Title: Advisory Committee on Nuclear Waste  
133rd Meeting

Date: Wednesday, March 20, 2002

High-Level Waste Performance Assessment

Sensitivity Studies

## Barrier Component Sensitivity- 10k years (continued)

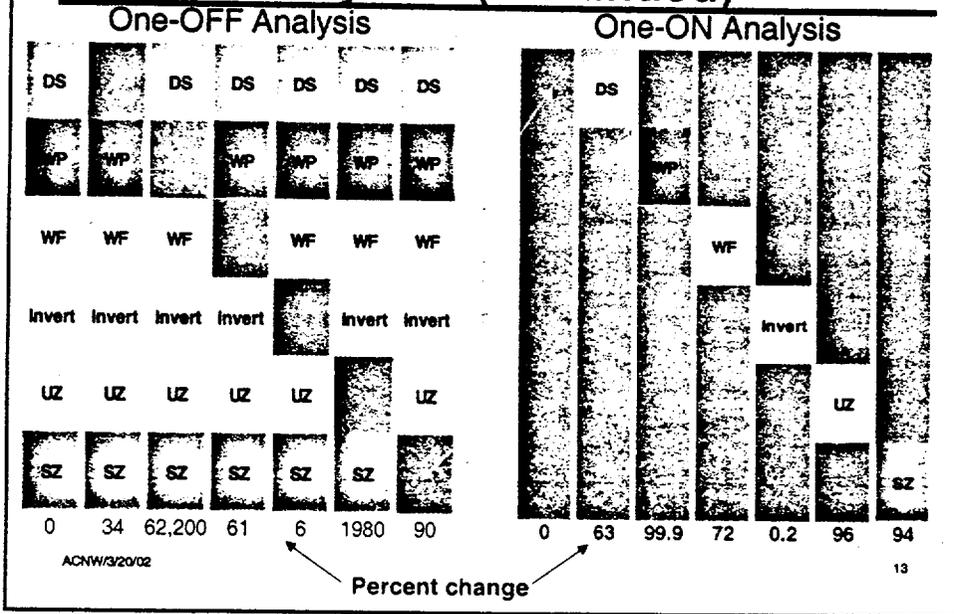
7 But on Slide 13, I'm having trouble  
8 relating this to the physical world in that on the  
9 one-OFF, if you remove the waste package, you have a  
10 62,200 percent change.

13 On the one-OFF analysis, when you remove  
14 the waste package, you have a 62,200 percent change,  
15 but with the one-ON analysis, none of the other  
16 barriers are there. You just add the waste package.  
17 You only have 100 percent change. Factor 2. It  
18 doesn't seem consistent with the physical world, as I  
19 visualize it.

15 CHAIRMAN HORNBERGER: I have a question  
16 now that you have mentioned your one-ON analysis. If  
17 we look at that lefthand column, okay, you have a dose  
18 associated with that, is that right? What you said  
19 was that we could read those as 99.9 percent reduction  
20 in dose?

22 CHAIRMAN HORNBERGER: So my question is  
23 what is the dose in that lefthand column and how did  
24 you calculate it?

20 MR. MOHANTY: Let me explain the  
21 difference. Under the one-OFF analysis, the first  
22 column represents the nominal case. For the nominal  
23 case, the peak expected dose is .021 millirems per  
24 year, whereas under the one-ON analysis, we are  
25 determining the percent in change based on the first

1 column under one-ON analysis. And that number, I  
2 don't remember what that value is, but we are using  
3 that number to determine the change. So that means at  
4 most it can be that. So when we put the waste  
5 package, so 99.9 percent represents a reduction in  
6 what we observe under column 1.
